TO: Ryanne Sass, Plaza Street Partners
FROM: Stacey Nerger, Senior Planner
DATE: April 18, 2022
SUBJECT: Lincoln Professional Park – Preliminary Site Plan
Review Comments 03

LINCOLN PROFESSIONAL PARK FILING NO.1 PRELIMINARY SITE PLAN

HKS RESPONSE IN BLUE

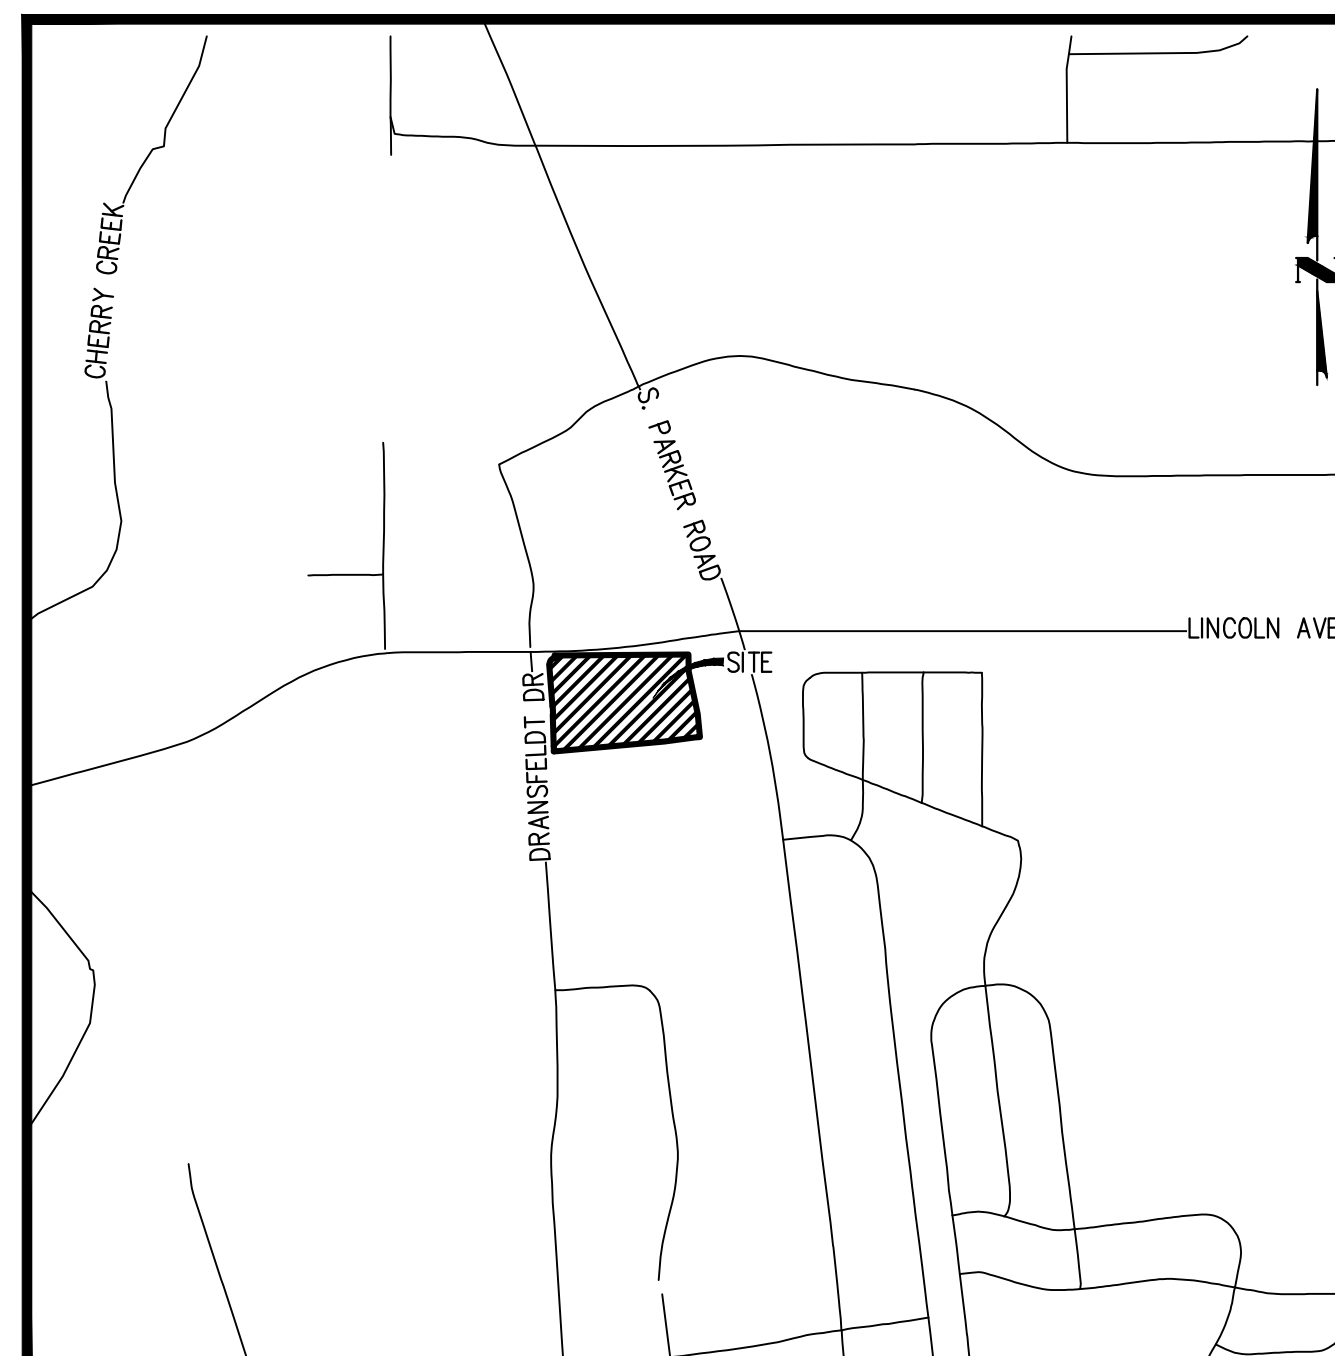
Automobile service (not including body or engine repair) will require a Use by Special Review to be allowed.

Is this an unbuildable lot?

Drive through restaurants, including coffee, require 1 parking space for each 100 square feet of net leasable area of building.

The C- Commercial Zone District requires all front setbacks to be a minimum of 40 feet, rear setbacks are 25 feet and side setbacks are 0 feet (none). The Town is currently in the process of rewriting the Town code and the C-Commercial District will go away and be replaced with a new zone district.

ACKNOWLEDGED

YES, DUE TO SIZE AND SETBACK REQUIREMENTS, LOT IS UNBUILDABLE

REVISED

TABLE REVISED

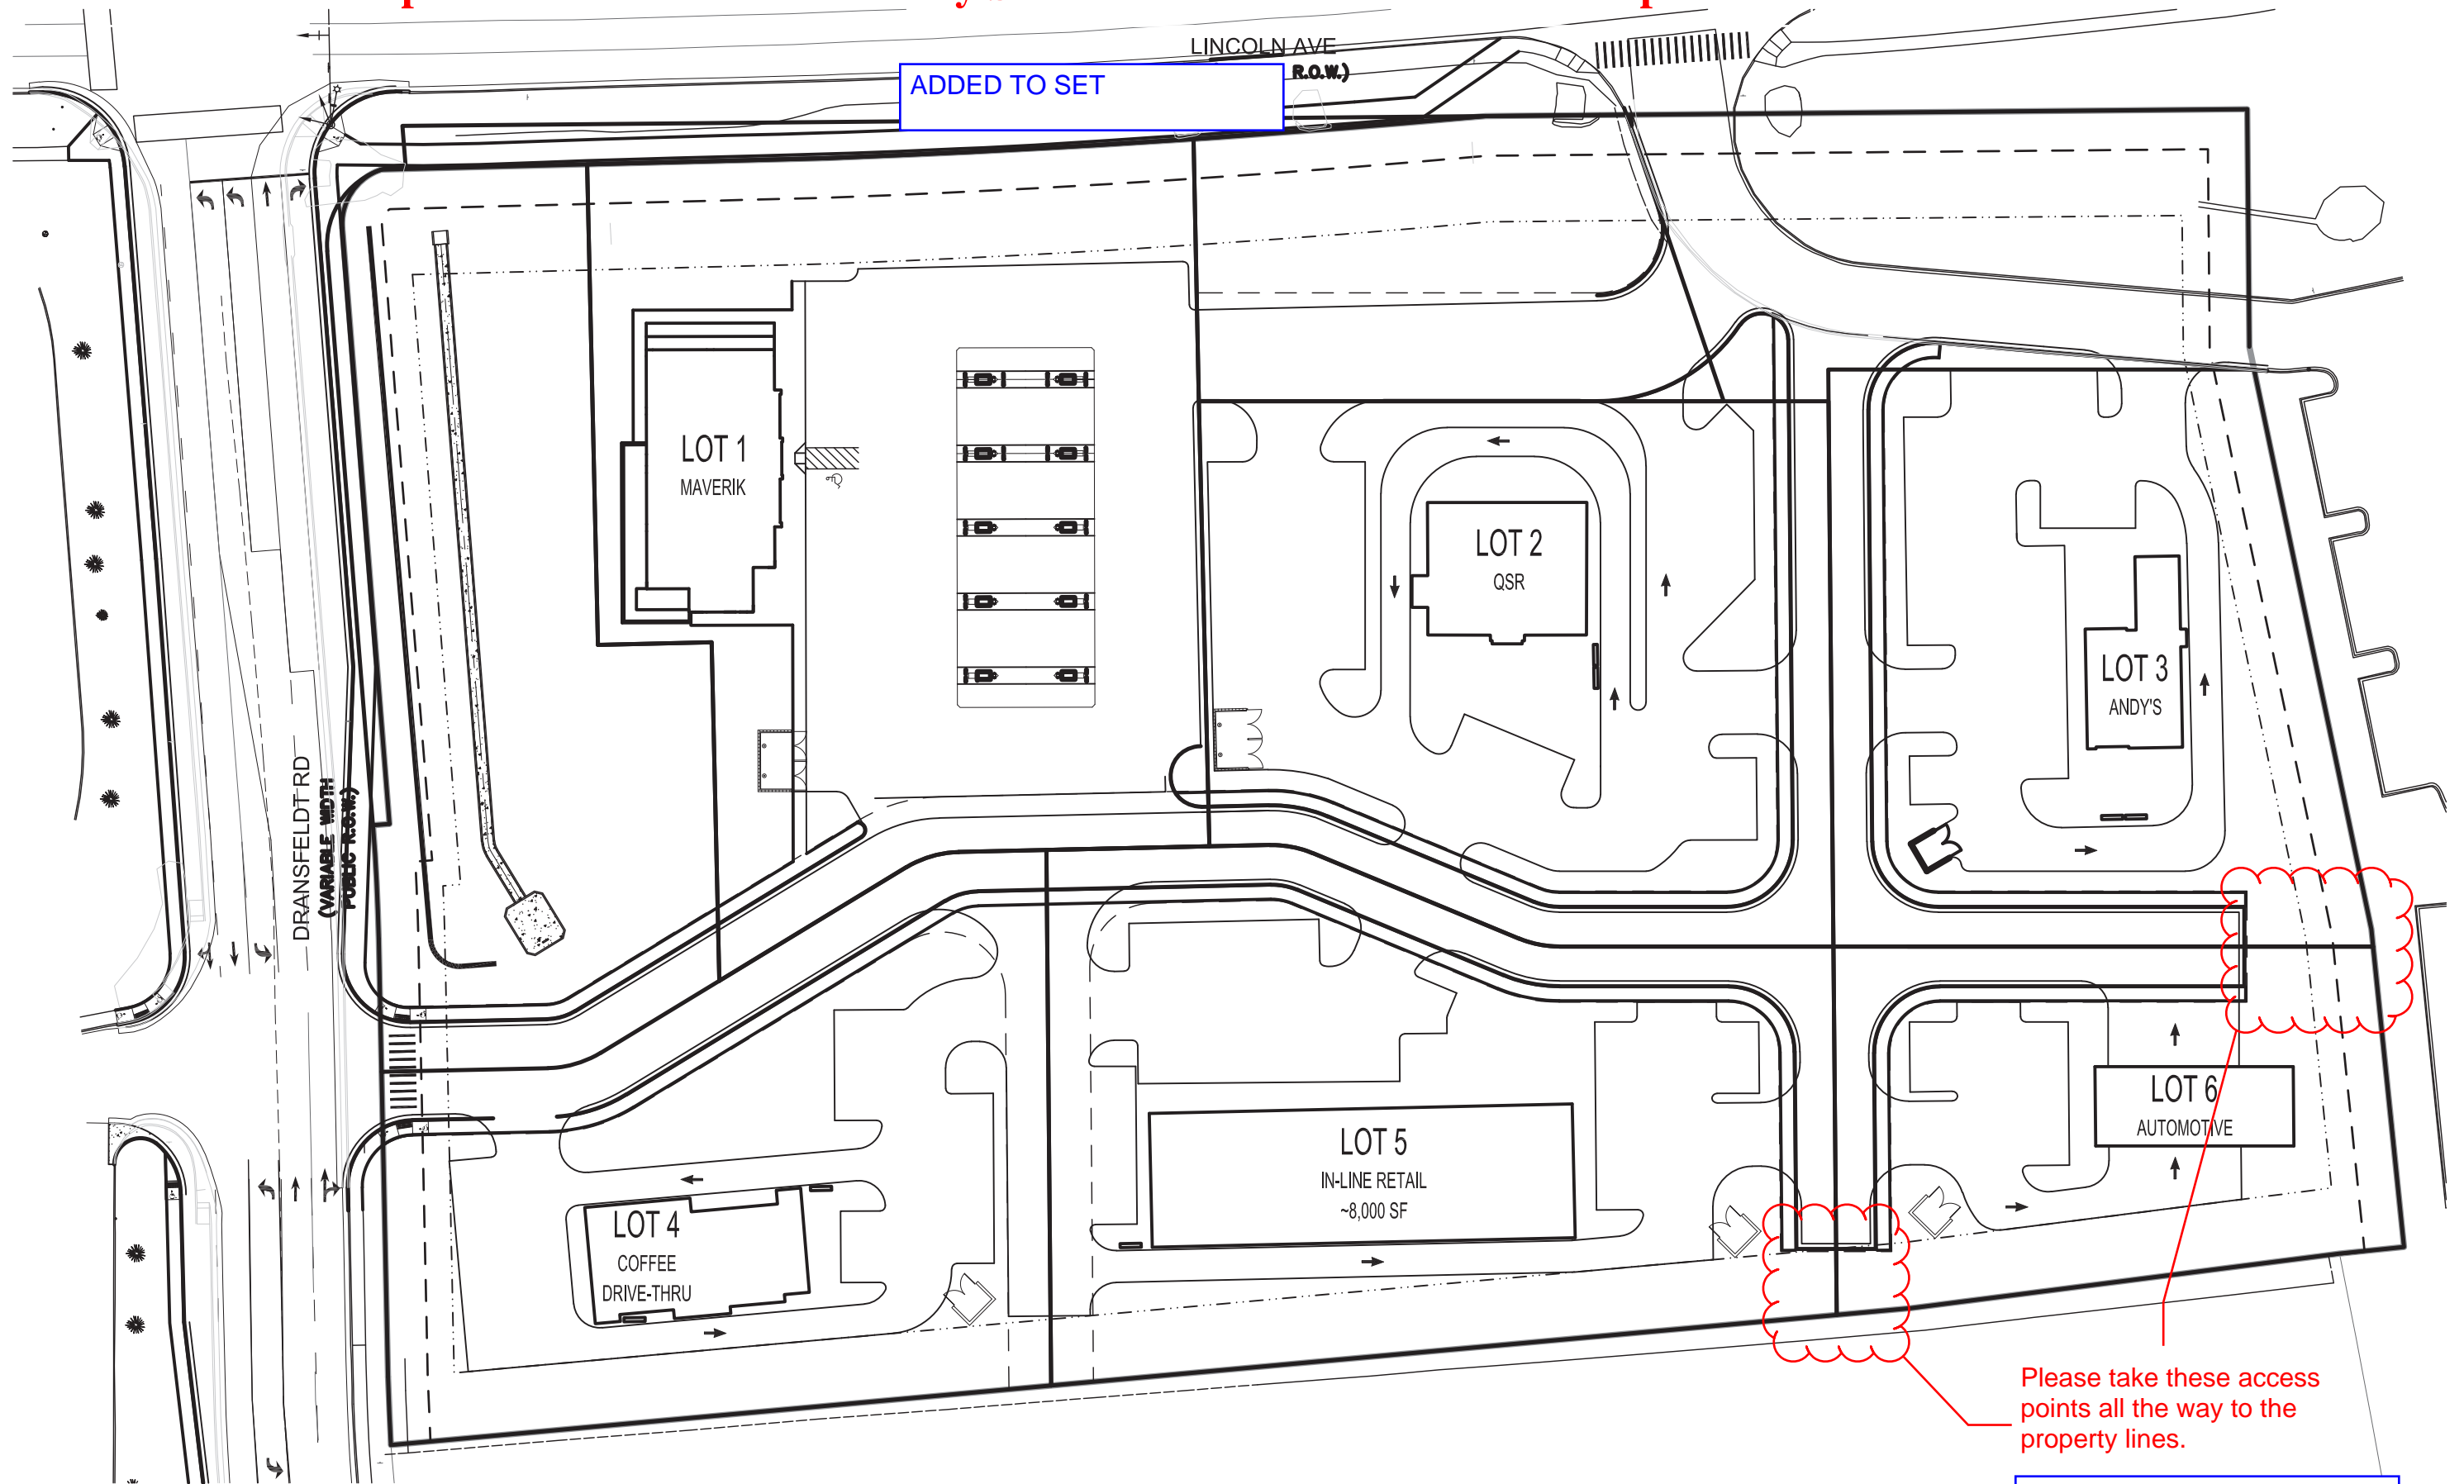
Include this as part of the 4 sheet Preliminary Site Plan and add the title to the top.

Please take these access points all the way to the property lines.

As it is laid out now, this lot is not developable, but moving the access road slightly to the south opens this lot to a future development out somewhat laid out here.

ADDED TO SET

REVISED

SHIFTING ACCESS TO SOUTH DOES NOT WORK FOR LOT 1 AND GAS TRUCK TURNING MOVEMENT REQUIREMENTS

LANDSCAPE PLAN
SHEET 3 OF 4

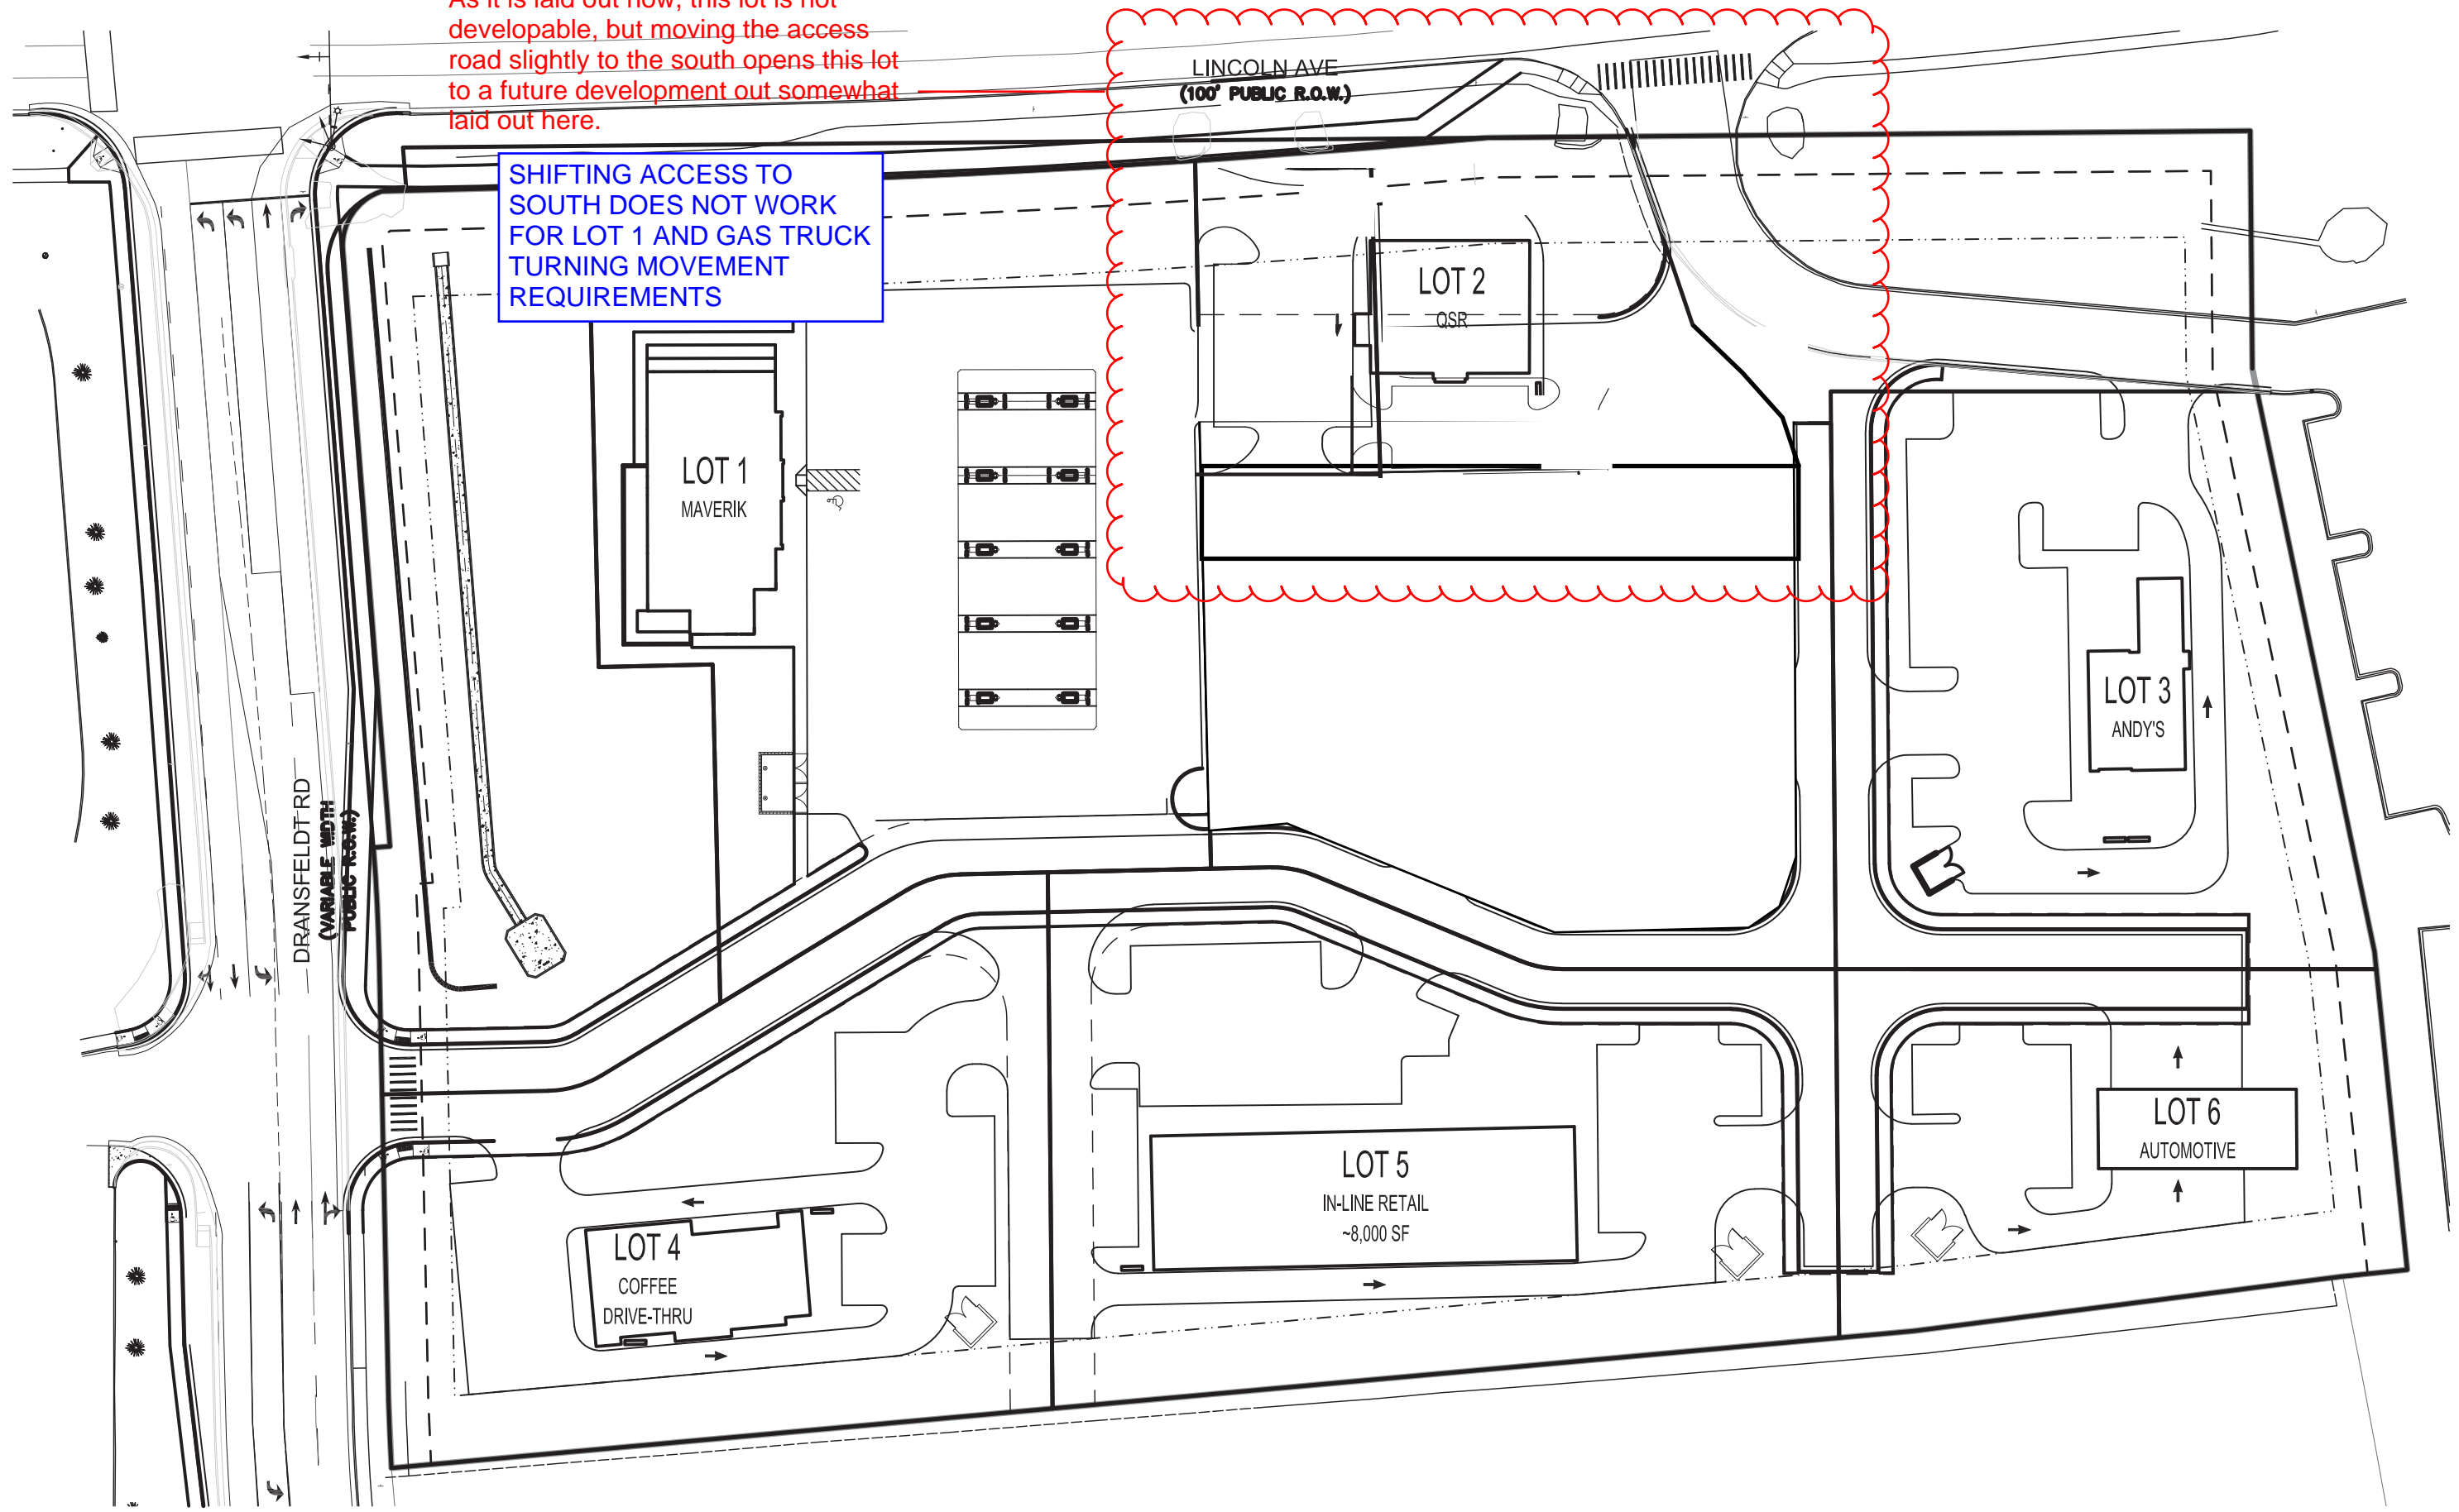
As stated in previous comments, per the Annexation Agreement, the Dransfeldt Road sidewalk is required to be detached with an 8 foot planting bed along the roadway and then a 5 foot sidewalk. Please amend the plans to show this. In addition, the sidewalk and landscaping should be part of the Minor Development Plat and can be copied from there.

The sidewalk internal to the site will also need to be detached with the tree lawn (streetscape) located adjacent to the roadway.

REVISED

OWNERSHIP DESIRE IS TO KEEP ATTACHED WALK ON INTERNAL ROADS AND THAT LANDSCAPING WILL BE HANDLED BY EACH INDIVIDUAL LOT

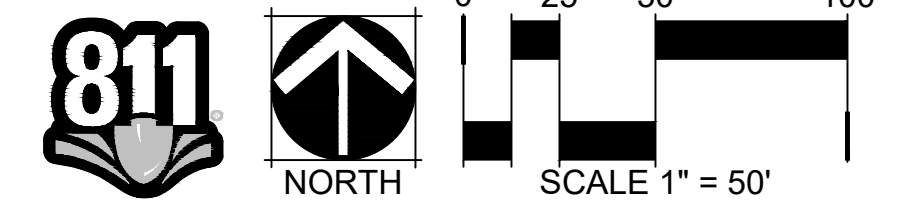
Break this down by the following:
 Road Name
 Dransfeldt Road
 Lincoln Avenue
 Internal North/South Road (or name of road)
 Internal East/West Road (or name of road)

REVISED
